PACKARD MOTOR CAR COMPANY

Counselor

VOL. 25, NO. 12

NOVEMBER 1, 1951

Steering Wheel Puller Adapter

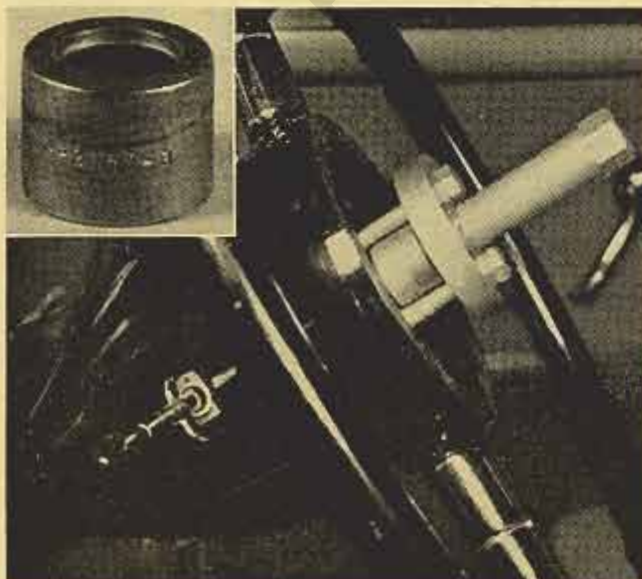
An adapter, J-2557-3, is now available and is used with the Steering Wheel Puller J-2557, as illustrated.

The adapter when threaded on the end of the main steering shaft prevents damage and spreading of the main shaft as the load or tapping is applied through the main screw of the puller.

When using the adapter with the puller, remove the two $\frac{1}{8}$ nuts from the capscrews in the puller as the nuts will not clear the adapter. Loosen the steering wheel until the hub of the wheel strikes against the lower edge of the adapter. Remove the puller and adapter and lift off the steering wheel.

Gasoline Tank Filler Pipe

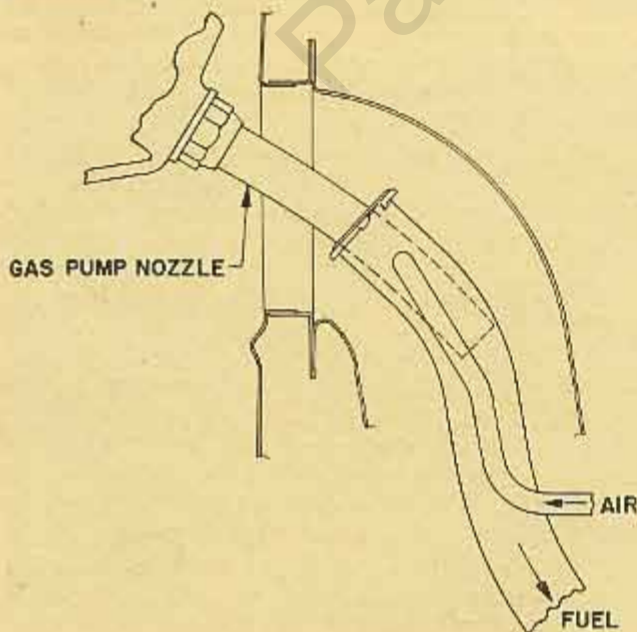
A few reports have been received that the gasoline tank filler pipe was not aligned with the gasoline filler pipe access door opening.

This makes it difficult to remove the gasoline filler pipe cap, and for the gas station attendant to properly insert the gasoline hose nozzle. If the hose nozzle is not inserted far enough past the vent opening, thus restricting the air vent in the filler pipe, it will contribute to a slow filling of the gasoline tank or spilling out during filling.

Loosen the gasoline tank straps and shift the tank to the left as far as possible, but be sure the tank ribs are not quite touching the ribs of the trunk floor panel, since contact may develop a squeak at this point. (See arrows on illustration.) Moving the tank to the left will move the filler neck outward with relation to the access door opening so the gasoline hose nozzle can be inserted more easily. Note the position of the gasoline hose nozzle in the filler neck shown on the illustration.
